SPRING BROOK INTAKE DAM

NDI ID NO. PA-00450  
DER ID NO. 35-40

PHASE I INSPECTION REPORT  
NATIONAL DAM INSPECTION PROGRAM

APRIL 1980

PHASE I INSPECTION REPORT  
NATIONAL DAM INSPECTION PROGRAM  
SPRING BROOK INTAKE DAM  
PENNSYLVANIA GAS  
AND WATER COMPANY  
RESULTS OF  
VISUAL INSPECTION  
APRIL 1980 EXHIBIT B-1

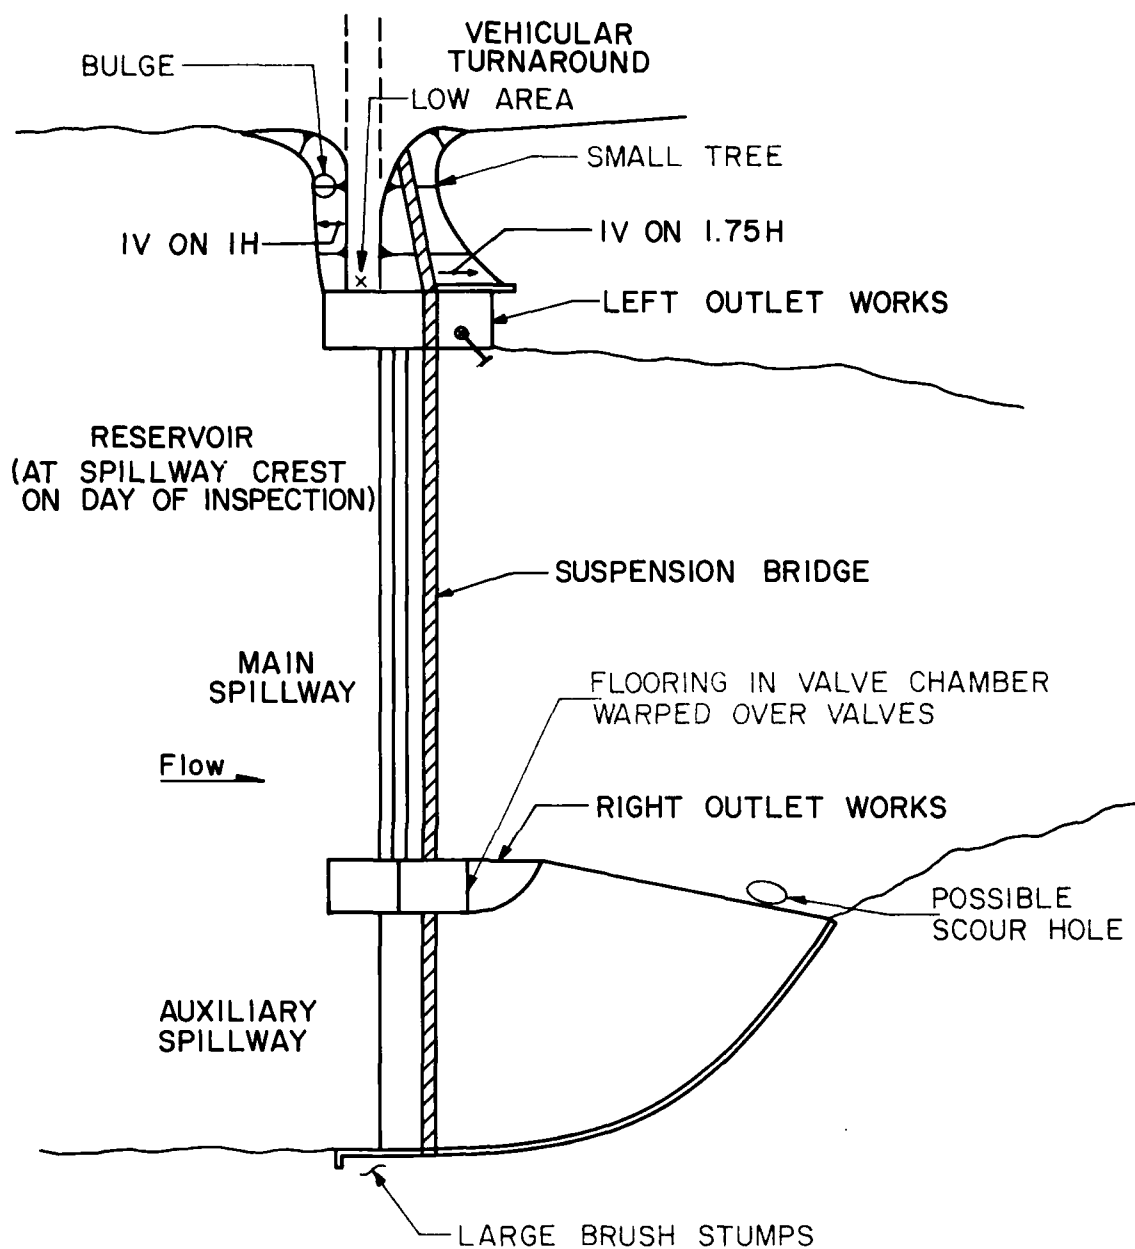
a. General. The overall appearance of the dam is good. Some deficiencies were observed as noted below. A sketch of the dam with the locations of deficiencies is presented on Exhibit B-1 in Appendix B. Survey information acquired for this Report is summarized in Appendix B. Datum for the survey was taken at the main spillway crest, Elevation 910.0, as shown on USGS mapping. The Owner uses a different datum. To convert the elevations on the Plates in Appendix E, 794.1 feet must be added to the elevations on those Plates. On the day of the inspection, the pool was at the spillway crest level. The dam was revisited about 2 weeks after the inspection so that additional photographs could be obtained. The spillway discharge shown on the photographs is significantly greater than the discharge that was occurring on the day of the inspection. During the revisit, it was noted that the Owner had regraded the top of the embankment. He subsequently reported that the regrading had been performed when a chlorine line to the water supply facilities was installed. He did not have any elevation data for the regrading. However, the top of the embankment is higher than indicated by the profile in Appendix B.

A. Embankment - Downstream Slope

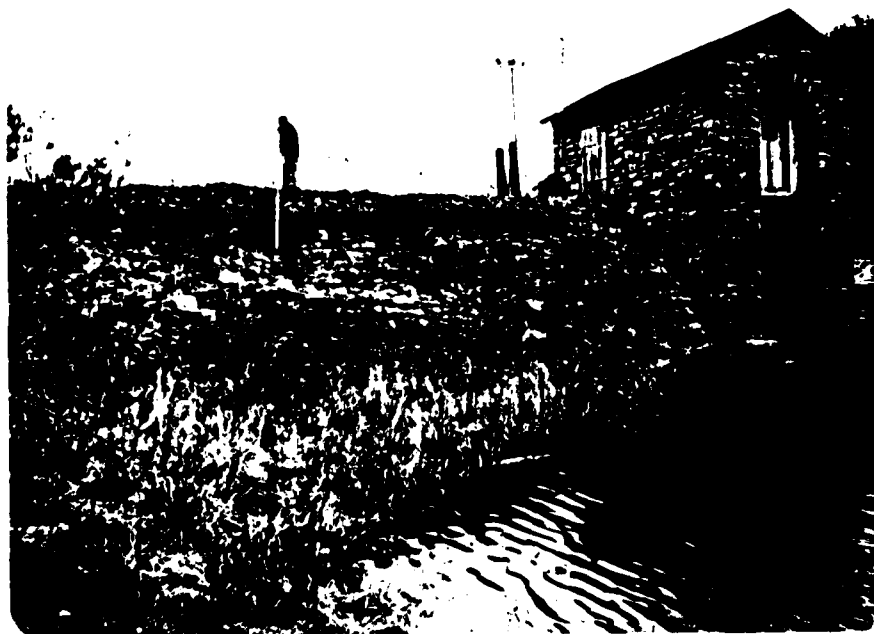
b. Embankment. The lower part of the downstream slope is grass covered. The upper part of the downstream slope and the top of the embankment are bare soil (Photograph A). One small tree is growing at the downstream toe (Photograph B). The part of the upstream slope that is above normal pool is protected by hand-placed riprap. There is a bulge on the upstream slope that protrudes a maximum of about 3 feet (Photograph B). The upstream slope above normal pool is very steep. The slope flattens significantly near the normal pool elevation.

(5) As part of the regular maintenance program, remove the small tree at the toe of the embankment and increase the frequency of brush cutting.

B. Embankment - Upstream Slope and Left Outlet Works

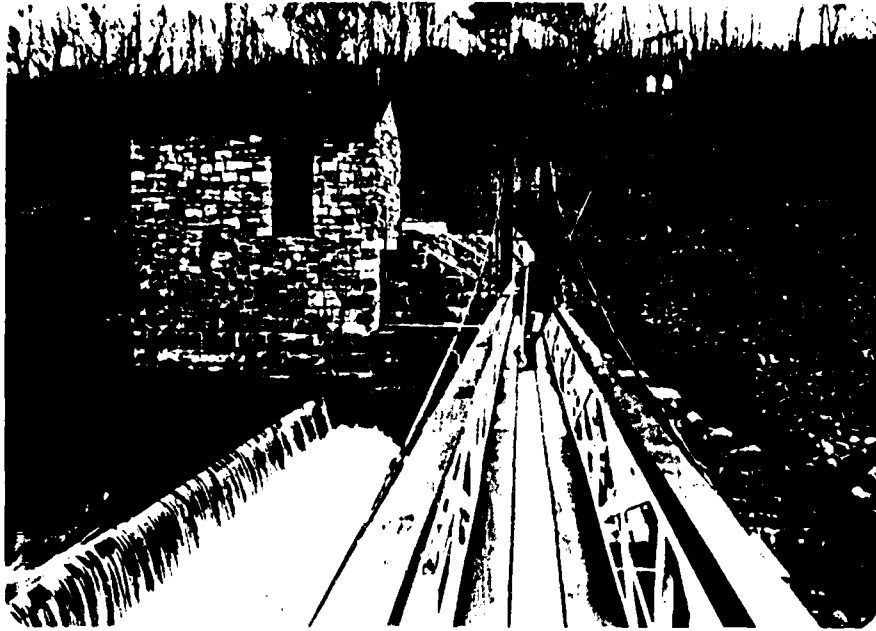
The bulge on the upstream slope of the embankment is a hazard to the dam. The 1V on 1H part of the upstream slope only extends down to Elevation 912.5, which is 2.5 feet above normal pool. This slope is much steeper than slopes normally used on earthfill embankments. Because the toe of the steep slope is above normal pool level and because the bulge appears to be a localized stability problem that does not extend below Elevation 912.5, a hazard would only exist when the reservoir is substantially above normal pool levels. The bulge is not noted in any previous inspection performed by either the Commonwealth or the Owner. The bulge was known to exist in June 1978, when a brief visit to Spring Brook Intake Dam was made as part of the Phase I inspection for Nesbitt Dam. As the top of the embankment is used for vehicular access, vehicular surcharge loadings may have caused the bulge. Were a slide to occur at the area, the top of the dam would be lowered; this would reduce the spillway capacity.

(2) Flatten the upstream slope of the embankment or provide other remedial measures as required to remove the bulge and stabilize the slope. The design of these measures should be performed by a professional engineer experienced in the design and construction of dams.

H. Auxiliary Spillway Apron

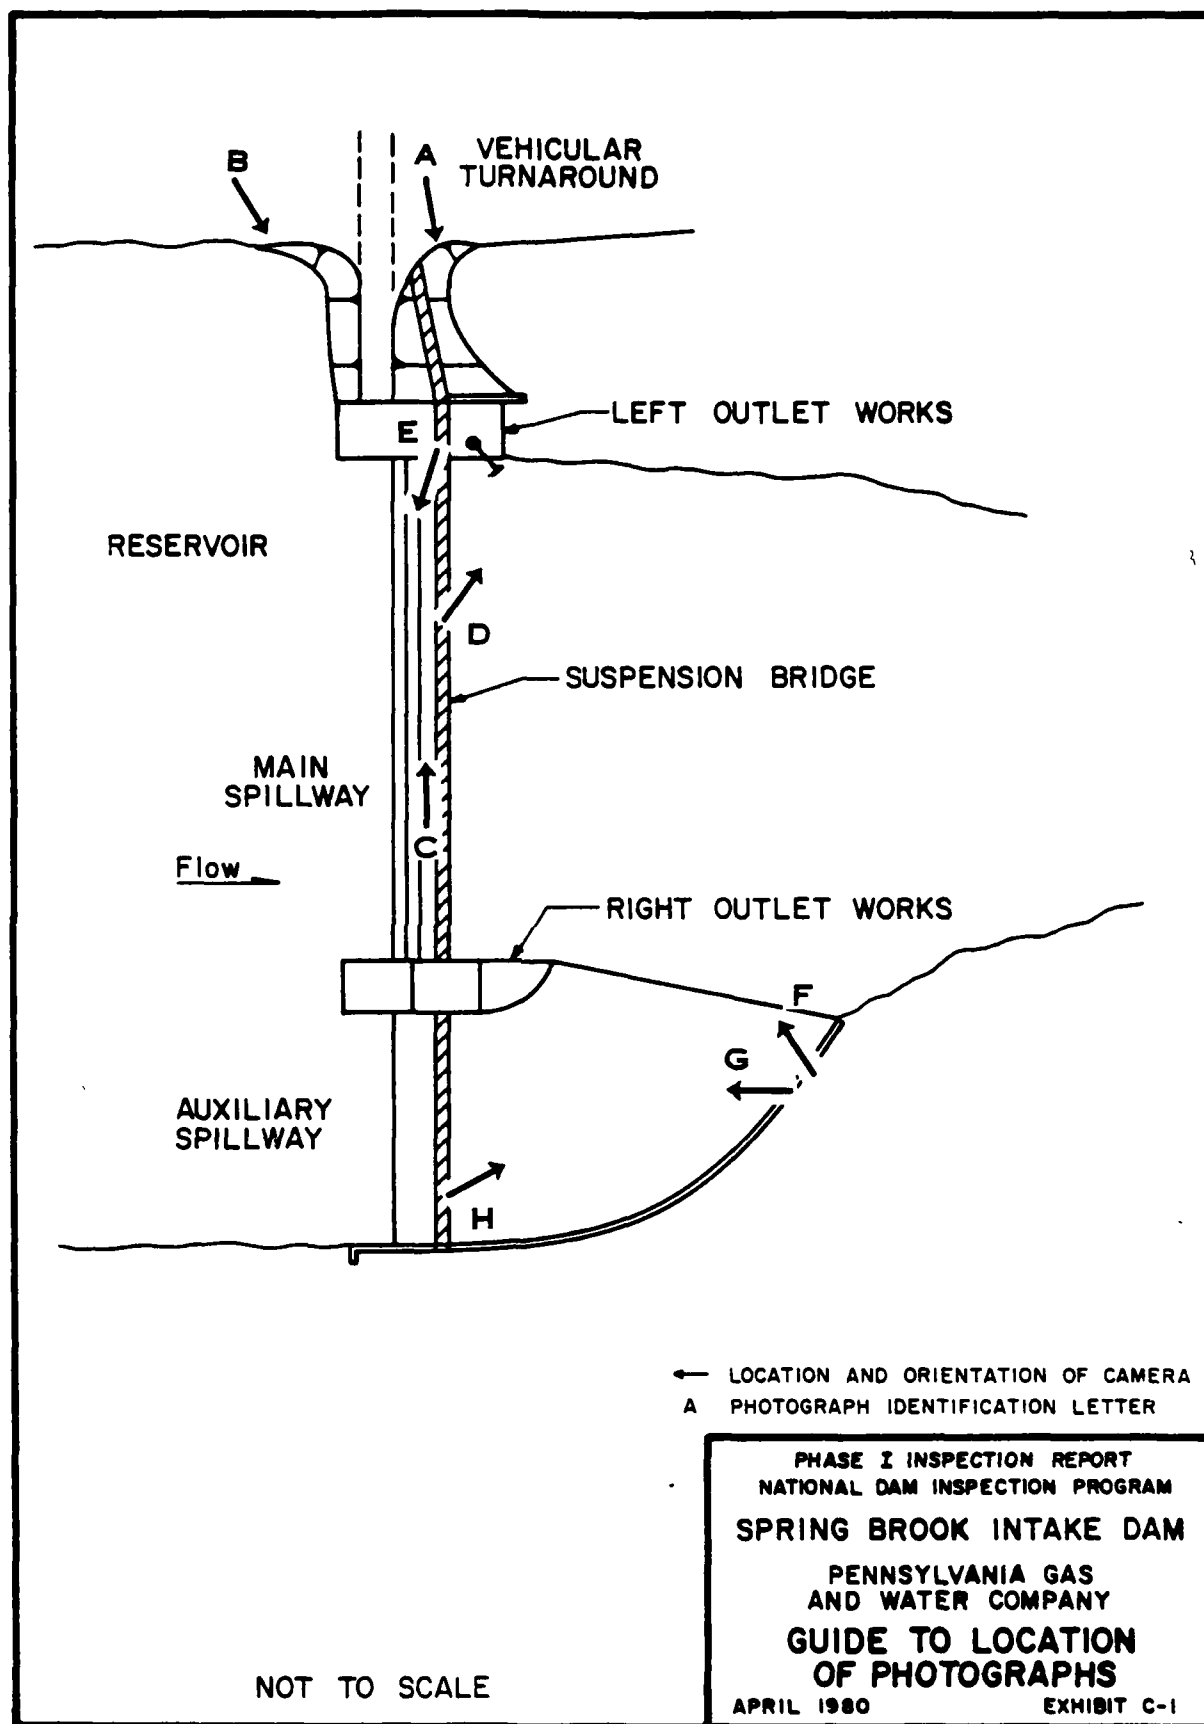
(3) Appurtenant Structures. No deficiencies relevant to hydraulics were observed at the main spillway, the main spillway apron, or the auxiliary spillway. The hole at the toe of the auxiliary spillway apron may indicate scour has occurred at this area. As shown on Plate E-2, a structure used to exist at this area. It is also possible that the hole may be the foundation of the

structure. If scour has occurred, then the auxiliary spillway apron could be undermined. This would not be a hazard to the dam unless it were to be neglected for a long time.

(4) Investigate the toe of the auxiliary spillway apron to determine if scour has occurred. If it has occurred, provide remedial measures.
